## Service Bulletin: TMIB-0144

**Topic:** Loose Output Nuts on Low Mileage Transmissions

## Output Nut with vs. without phosphate coating

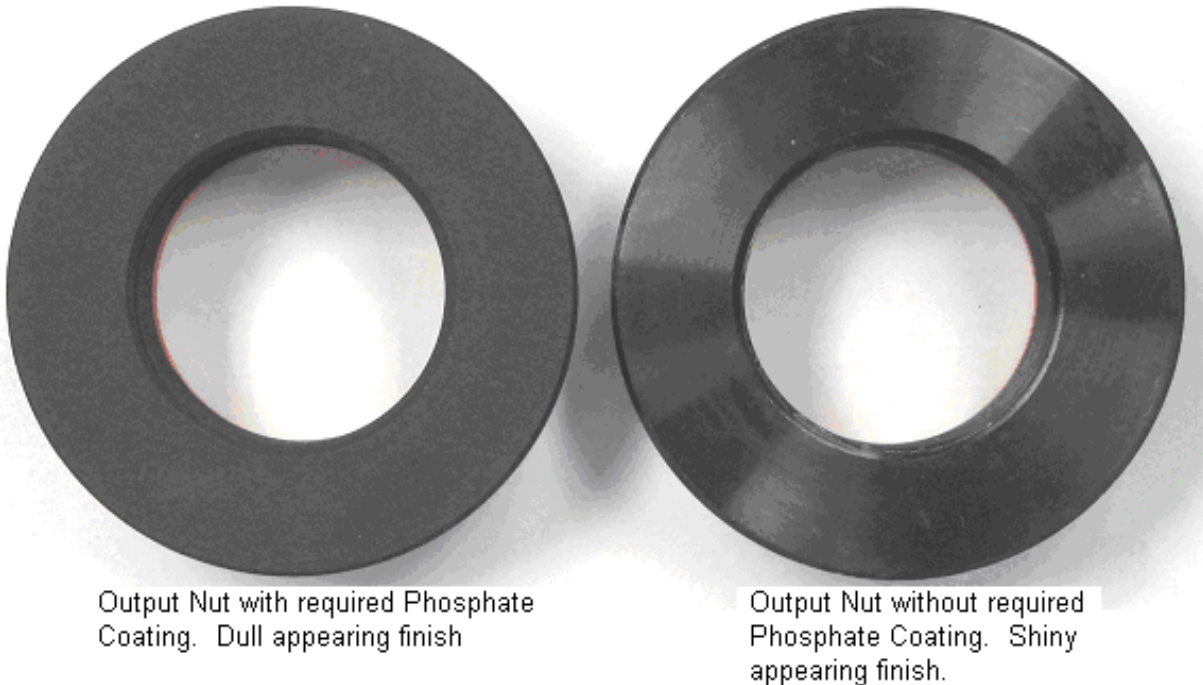
The output nut missed a required process, which applies a phosphate coating to allow lubrication between the flange face of the nut and the output yoke during the tightening process. Friction between the nut and output yoke may give a false reading of torque when tightening the output yoke nut.

Output Nut with required Phosphate Coating. Dull appearing finish

Output Nut without required Phosphate Coating. Shiny appearing finish.

When installing an output nut that is suspect of not having the phosphate coating a small amount of oil or grease should be applied to the flange face of the output nut before installing. If unsure which output nut you have grease should be applied to ensure proper tightening

1. Remove output nut
2. Inspect threads on output shaft for damage. (If damage is present replace auxiliary output shaft. Follow repair procedures for R&R and disassembly/assembly of auxiliary section).
3. Apply grease to flange face and threads of a new output nut.
4. Tighten output nut to 500 lb ft.
5. To ensure output yoke is tight attempt to spin speedo rotor.
